**COMMISSION ACTION FORM**

**REQUEST: MAJOR SITE DEVELOPMENT PLAN FOR 2121 COTTONWOOD ROAD**

## Attachment B: Major Site Development Plan (Parking Layout)

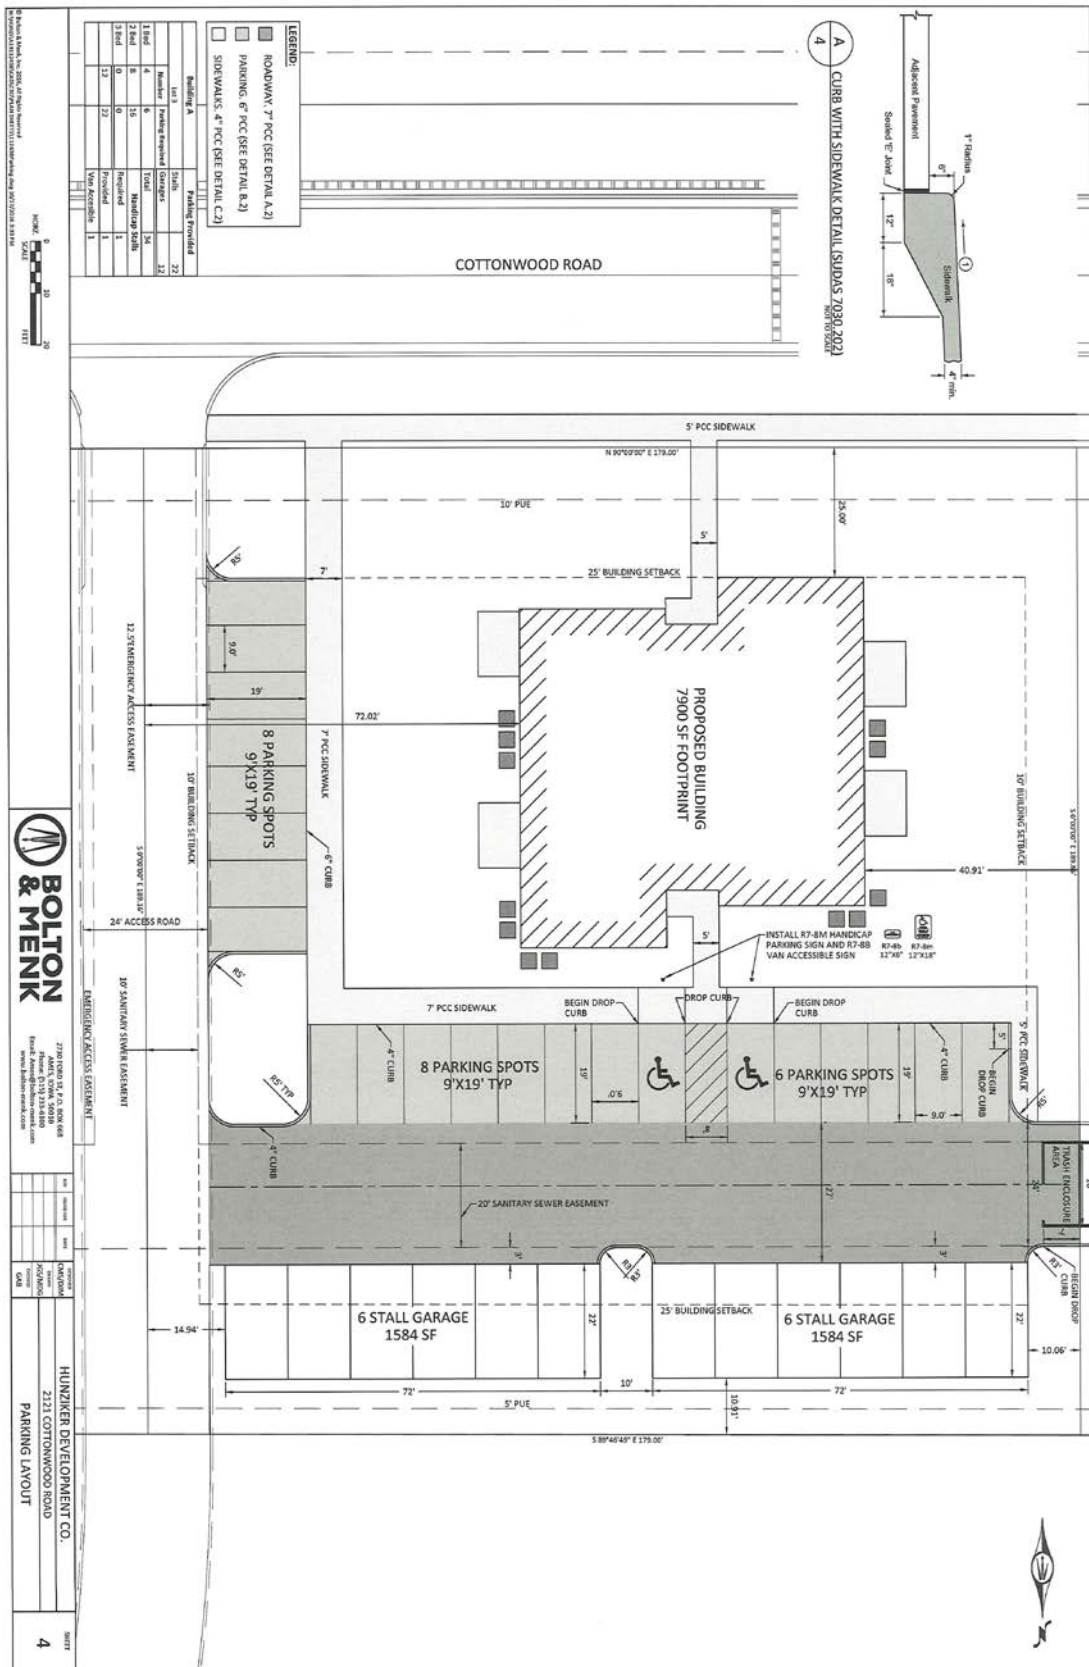
The Zoning regulations require a minimum of one parking space per bedroom for units of two bedrooms, or more, and one and one half parking spaces for one-bedroom units. The minimum number of parking spaces required for this site is twenty-two spaces. The developer is proposing a total of 34 parking spaces, including handicap-accessible spaces and garage stalls. Off-street parking on the site is configured as eight standard (9'x19') surface parking spaces in the side yard, east of the building, and twelve standard surface parking spaces, plus two van-accessible handicap spaces, as required, in the rear yard behind the building. Across the drive aisle from the surface parking spaces in the rear yard, are two (6-stall) garages approximately 10.91 feet from the north property line, and running parallel to the north perimeter of the site. The parking spaces, and garage stalls, are served by a single access from Cottonwood Road, centered on the property line that separates Lots 2 and 3 in a 25-foot wide access easement. The shared access between Lots 2 and 3, also serves as a temporary emergency vehicle access that extends through the Wessex Apartment development adjacent to the north, and out to Oakwood Road, until such time that Cottonwood Road is extended to the west to connect with the existing Cottonwood Road in the Suncrest Subdivision (*See Attachment B: Master Plan, Parking Layout*).

## Attachment B: Major Site Development Plan (Landscaping)

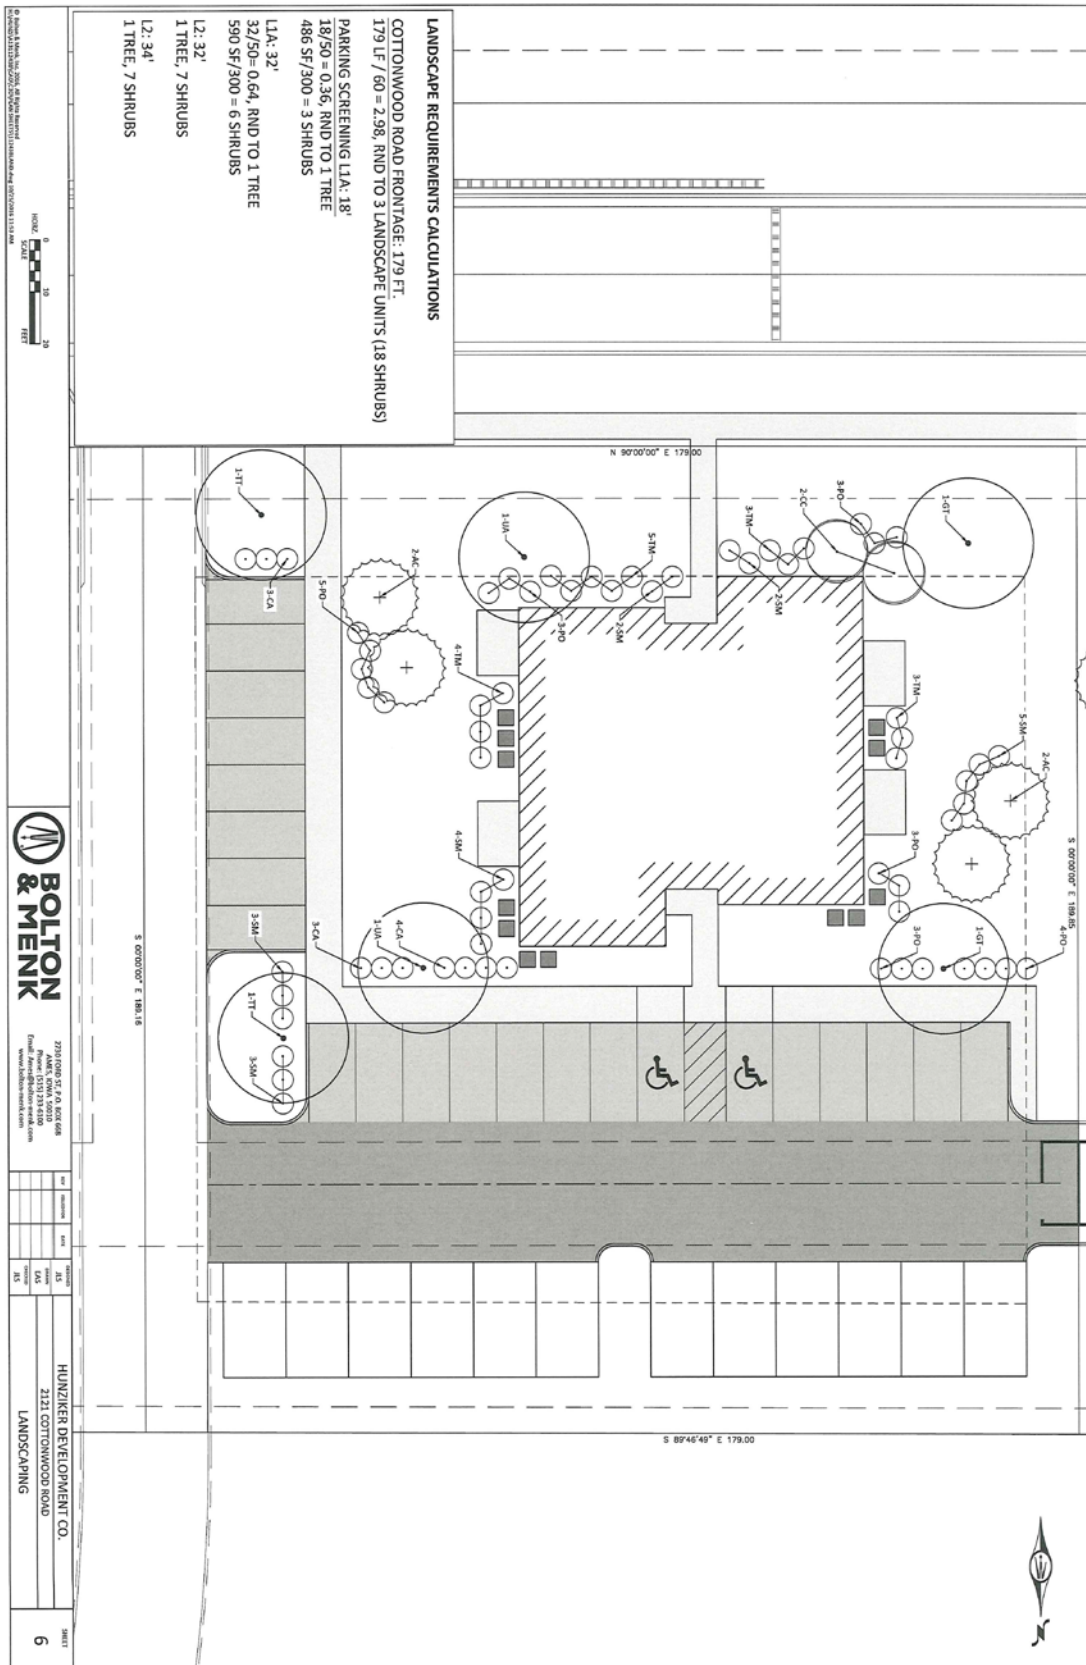
The Landscape Plan shows screening for mechanical units along the east and west sides of the building that meet site plan standards, provided the shrubs used for screening are a minimum of six inches higher than the mechanical units, at the time of planting. A condition is included in the report as a reminder of the need to comply with screening at the time of planting compared to growing into a screen over time.

No interior parking lot landscaping is required due to the size of the parking lot with one drive aisle. Perimeter parking lot landscaping is required along the portions of the driveways, parking spaces, and drive aisles to meet perimeter parking lot landscaping. All but one area of the site has the required perimeter parking lot landscaping. The side of the parking space that faces the property at 2135 Cottonwood, to the west, requires five shrubs to meet the "L2"(Low Screen) landscaping standards. The developer does

not believe landscaping is needed at the terminus of this drive aisle as it abuts another drive aisle. The City Council can approve modification of landscaping screening requirements if it finds that an alternative design meets the objectives for parking lot screening. Staff finds that the minimal length of area could be planted, but the overall mix of plants has diversity and interest in the design while meeting the essence of screening objectives of the zoning ordinance (*See Attachment B: Major Site Development Plan, Landscaping- pg 18*).

- E. Prior to occupancy of the apartment building at 2121 Cottonwood Road, shrubs used as screening for mechanical units must be installed to meet zoning standards at a minimum height that is six inches higher (at the time of planting) than the mechanical equipment the shrubs are screening.
